10/552,376

VERDIER, CHRISTOPHER M

Office Action Summary	Application No. 10/552,376	Applicant(s) CHEN, HUA	
	Examiner Christopher Verdier	Art Unit 3745

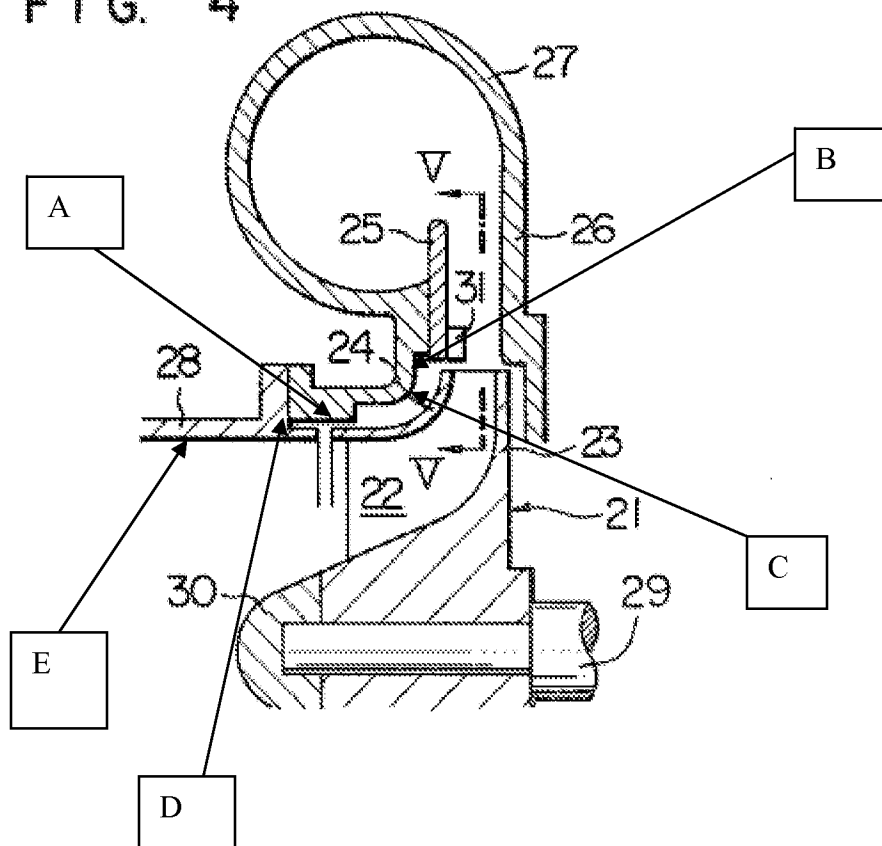
Claims 1, 4, 5, 6, 9, 11, 12/6, 13/6, 14/6, 15/6, 12/9, 13/9, 14/9, 12/4, 13/4, 14/4, 15/1, 15/4, and 15/11 are rejected under 35 U.S.C. 102(b) as being anticipated by Yoshinaga 4,395,197. Disclosed is a compressor comprising a compressor wheel 21 having compressor

blades 22 and being mounted for rotation on a shaft 29, each blade being characterized by an upstream leading edge and a downstream trailing edge, and a shroud 27/28 mounted adjacent the wheel and defining a gas flow path between the shroud and the blades from a compressor inlet to a diffuser outlet, wherein in cross-section the shroud forms a surface A along the flow path, the surface being characterized by a profile that includes a relative discontinuity B in the region of the trailing edge, wherein the discontinuity forms a downstream-facing blocking face adapted to impede an upstream flow of gas between the shroud and the wheel, the blocking face extending across the flow path to form a sharp edge connecting the blocking face to a smoothly curving surface C upstream of the discontinuity. The cross-section profile of the shroud surface along the flow path is further characterized by a second relative discontinuity D that is in the region of the leading edge, wherein the second relative discontinuity forms a second downstream-facing blocking face adapted to impede an upstream flow of gas between the shroud and the wheel, the second blocking face extending across the flow path to form a sharp edge connecting the second blocking face to a second smooth surface E upstream of the second discontinuity. The second discontinuity is located upstream of the leading edge of the wheel blades. The second discontinuity is spaced from the leading edge of the wheel blades by a distance of the same order as the axial clearance of the trailing edge from the compressor housing. The or each downstream-facing blocking face comprises a planar surface cut into the curving surface. The second downstream-facing blocking face comprises a planar surface cut into the curving surface, and the planar surface is perpendicular to the axis of the shaft. The radial extent of the second discontinuity is of the same order as the radial clearance between the trailing edge and the housing. The sizes of the first and second discontinuities are closely similar. The shapes of the

FIG. 4

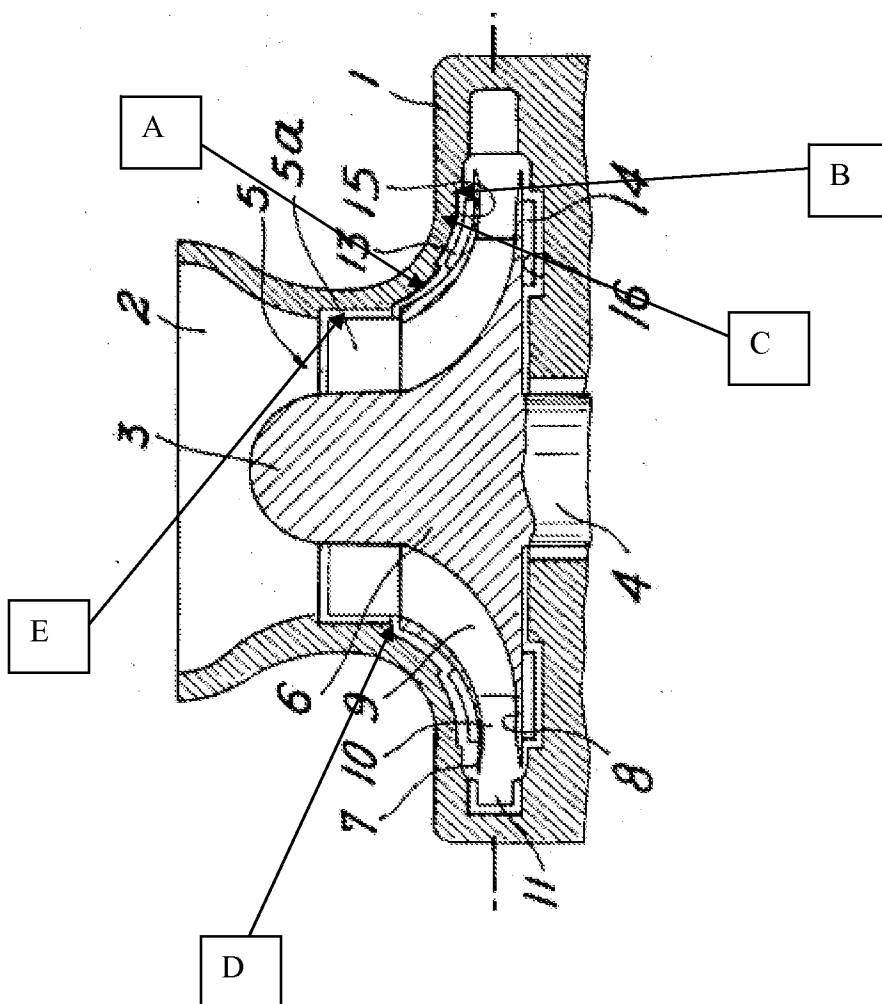
Claims 1, 4, 5, 9, 11, 13/9, 14/9, 13/4, 14/4, 15/1, 15/4, and 15/11 are rejected under 35 U.S.C. 102(b) as being anticipated by Fabri 3,824,029. Disclosed is a compressor comprising a compressor wheel 3/6 having compressor blades 9 and being mounted for rotation on a shaft 4, each blade being characterized by an upstream leading edge and a downstream trailing edge, and a shroud 1 mounted adjacent the wheel and defining a gas flow path between the shroud and the blades from a compressor inlet to a diffuser outlet, wherein in cross-section the shroud forms a surface A along the flow path, the surface being characterized by a profile that includes a relative discontinuity B in the region of the trailing edge, wherein the discontinuity forms a downstream-facing blocking face adapted to impede an upstream flow of gas between the shroud and the wheel, the blocking face extending across the flow path to form a sharp edge connecting the blocking face to a smoothly curving surface C upstream of the discontinuity. The cross-section profile of the shroud surface along the flow path is further characterized by a second relative discontinuity D that is in the region of the leading edge, wherein the second relative discontinuity forms a second downstream-facing blocking face adapted to impede an upstream flow of gas between the shroud and the wheel, the second blocking face extending across the flow path to form a sharp edge connecting the second blocking face to a second smooth surface E upstream of the second discontinuity. The second discontinuity is located upstream of the leading edge of the wheel blades. The or each downstream-facing blocking face comprises a planar surface cut into the curving surface. The second downstream-facing blocking face comprises a planar surface cut into the curving surface, and the planar surface is perpendicular to the axis of the shaft. The

sizes of the first and second discontinuities are closely similar. The shapes of the first and second discontinuities are closely similar. Concerning claim 15, the term “turbocharger” is recited in the preamble of the claim and has not been given patentable weight. A preamble is generally not accorded any patentable weight where it merely recites the purpose of a process or the intended use of a structure, and where the body of the claim does not depend on the preamble for completeness but, instead, the process steps or structural limitations are able to stand alone. See *In re Hirao*, 535 F.2d 67, 190 USPQ 15 (CCPA 1976) and *Kropa v. Robie*, 187 F.2d 150, 152, 88 USPQ 478, 481 (CCPA 1951). Note the annotated figure below.
